HOME OF JOSEPH A DAVIS, JR.
CLIFF ISLAND, MAINE

This will serve to confirm our conversation of this date. This was relative to the J. Davis garage on Cliff Island, lot # 109-A-B-4, building permit # 713.

Permit to erect an L.C. Andrews garage 24' x 32' as per plans is issued
herewith subject to the following Building Code Requirements.

Born on July 0. Curb Property.
 Subm. Tied by
 BERTHA M. DAVIS.
 Nov 8, 1952

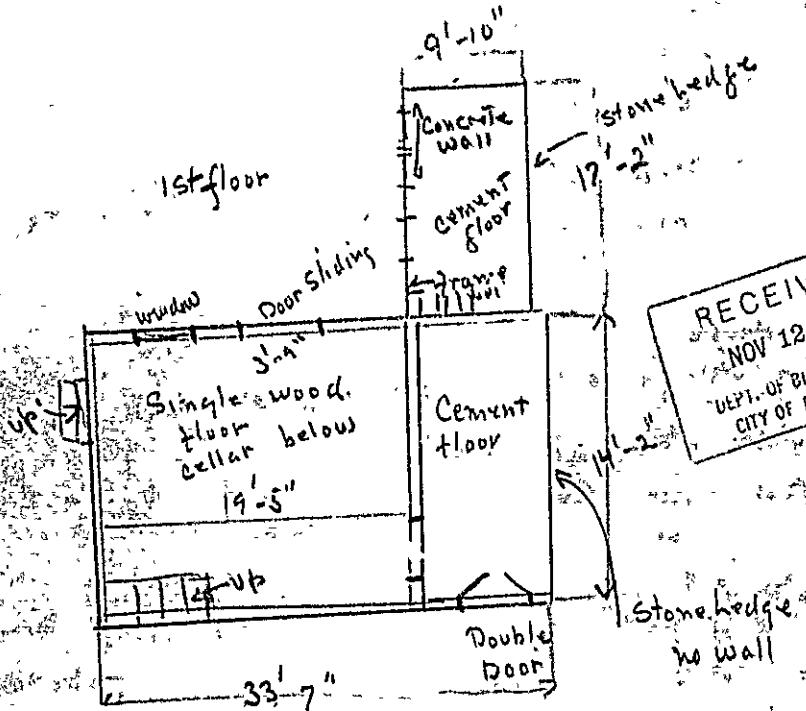
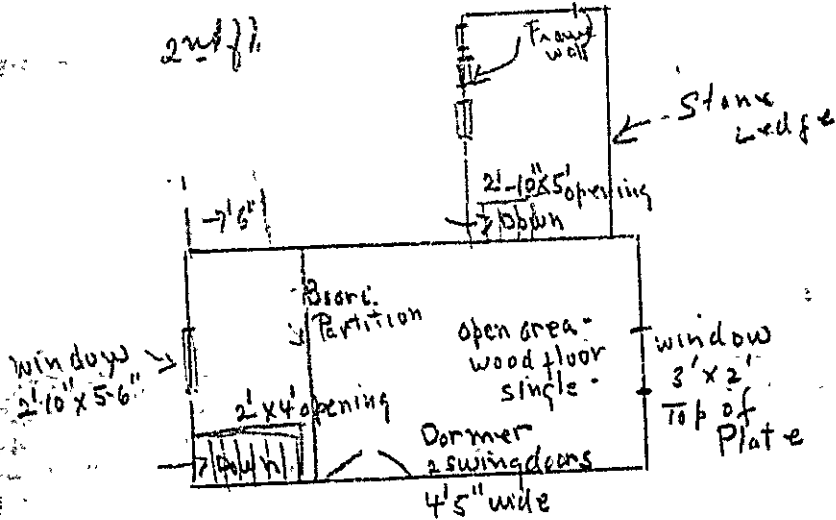
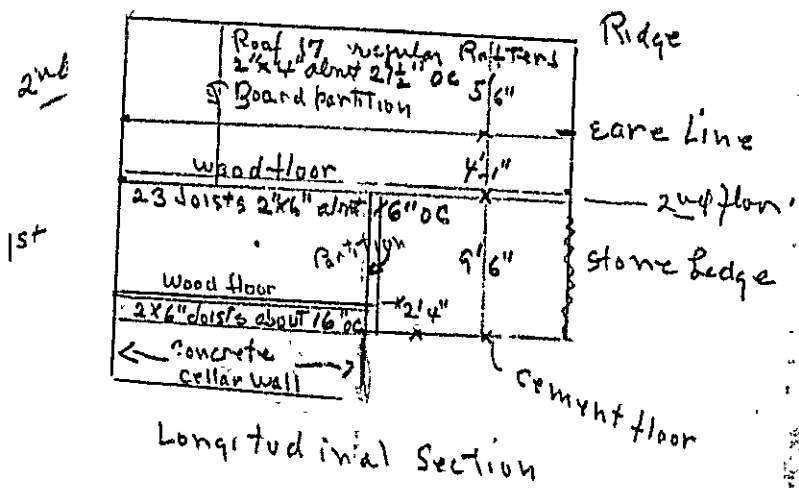
Compliance with the Building Code becomes another matter. I take it from your sketch that the first floor joists of the main building are 2x6 probably on spans of 14 feet (the width or depth of the building). This would be much too weak and would require a center girder with properly spaced piers or posts under it. I judge that the second floor joists are 2x6 and on the same span. This is similarly much too weak and the question of strengthening the framing becomes more difficult than the first floor because the large room (14 ft. x 19 ft.) below it would not permit any bearing partitions to subdivide it.

You have noted in at least one place "board partition". All partitions would require no less than 2x3 uprights no more than 16 in. from center to center and, 1" bearing partition, the uprights would have to be no less than 2x4.

We would need full details of the foundations, the size of sills, the size of corner posts and the size and spacing of studs or uprights in the outside walls in both stories.
